产品变更需求通知单 Product Spec Change Notice

PCN编号: PCN NO.:	PCN-C1460S_REV_A		
产品名称: Part Description	PLUG, 12 SOCKET, AT SERIES	安费诺料号: Amphenol P/N:	(详见料号清单)
订单号: P/O:	N/A	数量: Quantity:	N/A
变更性质: Change Property:	<input type="radio"/> 临时性 Temporary <input checked="" type="radio"/> 永久性 Permanent	有效期限: Effective Period:	N/A
变更项目: Change Item:	<input type="checkbox"/> 材质 Material <input type="checkbox"/> 尺寸 Size <input type="checkbox"/> 工艺 Process <input checked="" type="checkbox"/> 外观 Appearance <input type="checkbox"/> 表面处理 Surface treating <input type="checkbox"/> 性能 Performance <input type="checkbox"/> 其它 Others

before

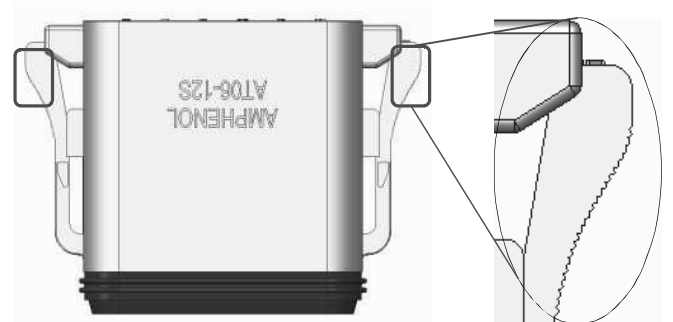
In an effort to continuously improve our products, We will change the slope of AT 12pos plug housing's latch, It will improve the insert and pull-out hand feeling.
 (为了持续改进产品, 我们将改变AT系列12芯插头按扣坡度, 提升插拔手感)

This is a continual change so the current and previous revisions of this part can be used interchangeably in the field. This change is being phased in gradually and previous revisions may remain stocked until use.
 (这是一次持续改进, 相对于现有和之前的产品, 产品可以混用, 此变更会一步步进行, 之前版本的库存会继续用完)
